EVERSTEAD SHOP DRAWINGS/SUBMITTAL REVIEW

APPROVED AS NOTED

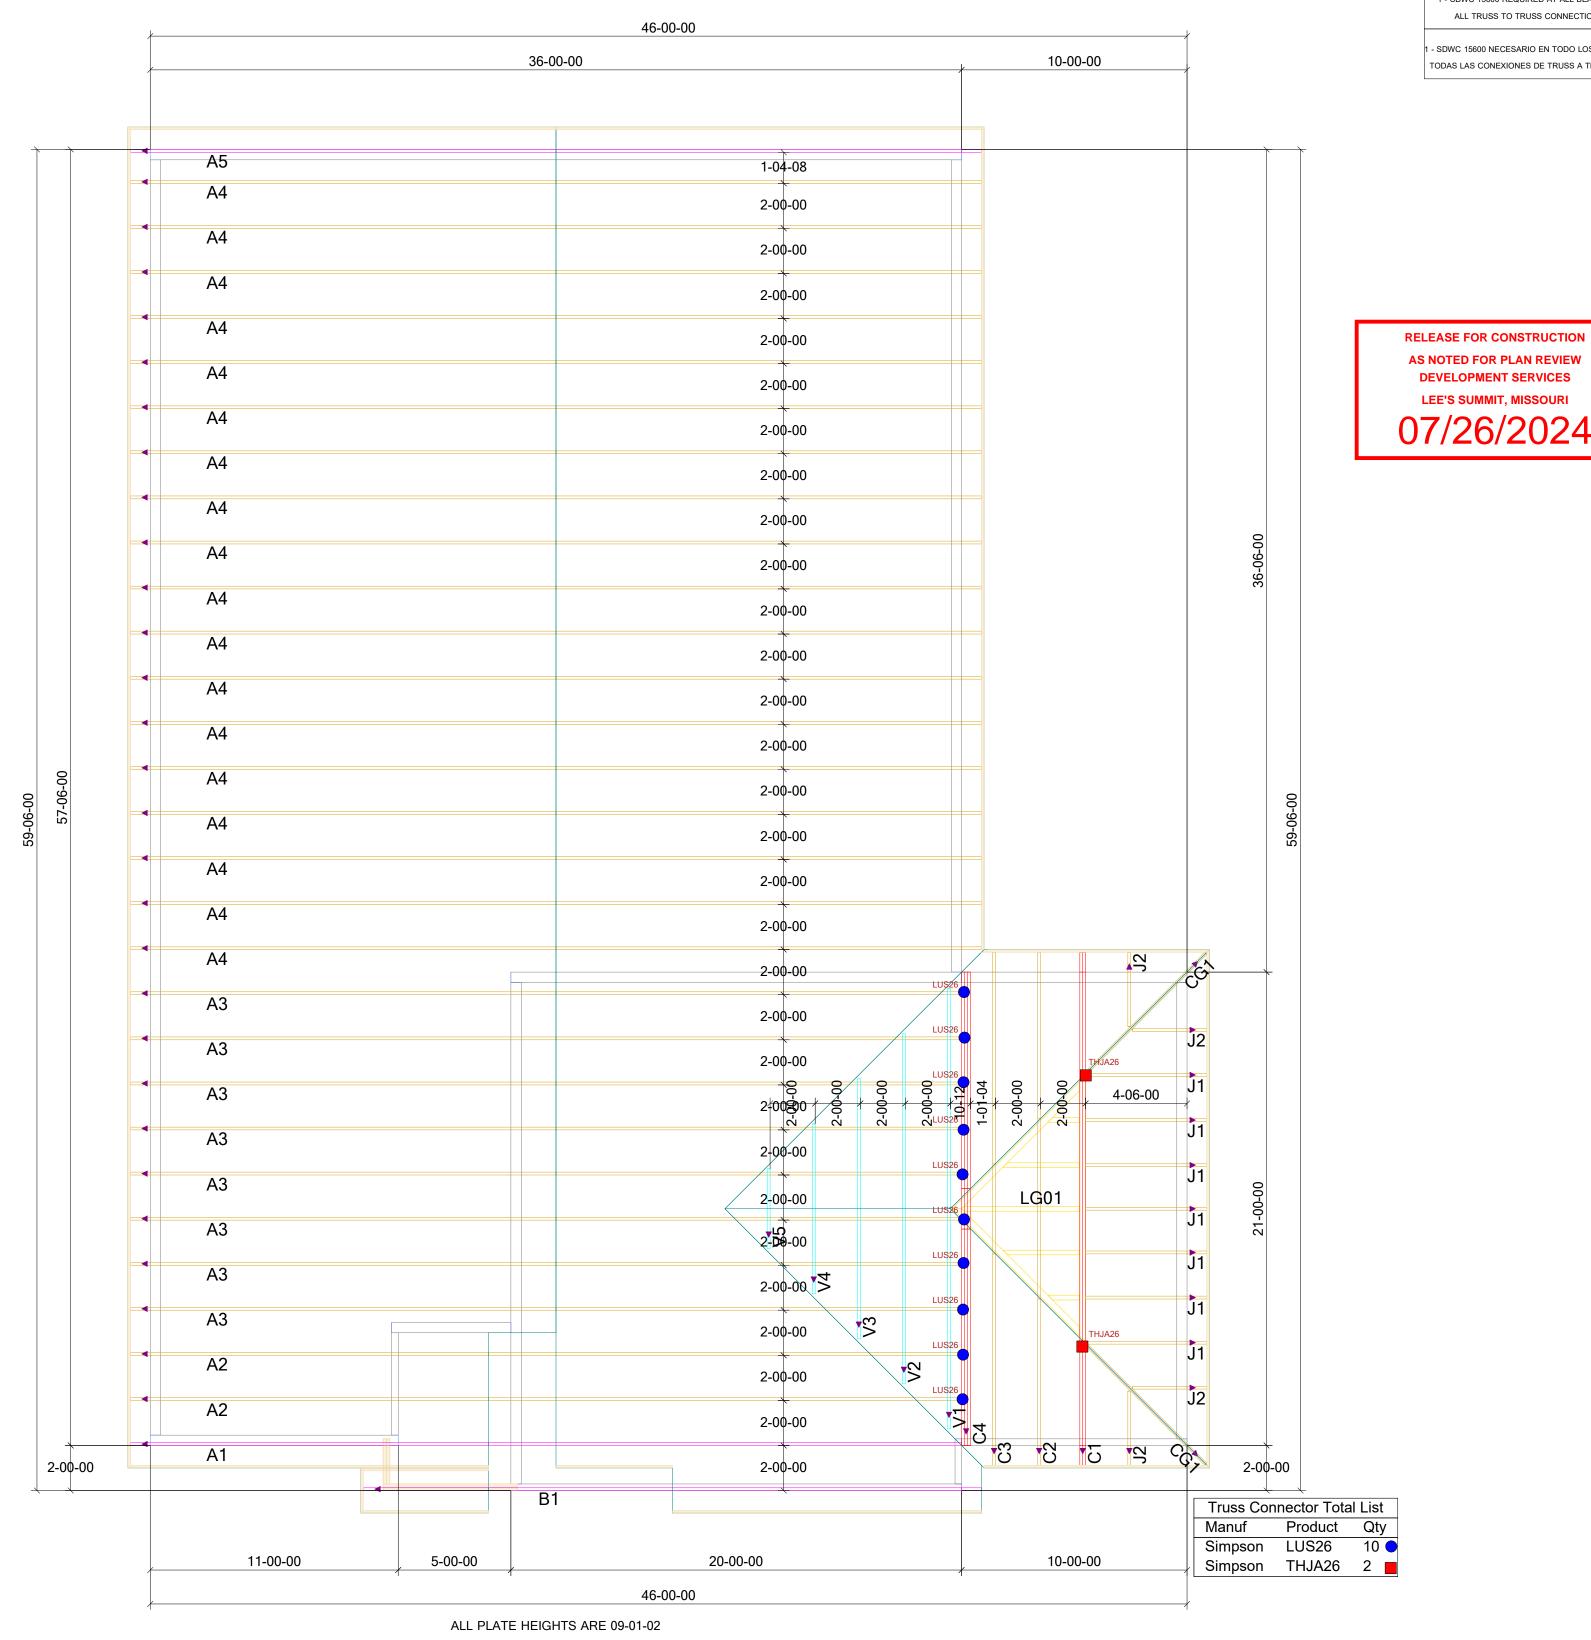
TRUSSES APPROVED BASED ON STRUCTURAL DESIGN. PLEASE NOTE THE PLANS STATE A 10' CEILING IN THE FOYER HOWEVER THE TRUSS SEALS DO NOT SHOW A RAISED CEILING IN THE FOYER. MANUFACTURER TO COORDINATE WITH WITH CONTRACTOR AS NEEDED.
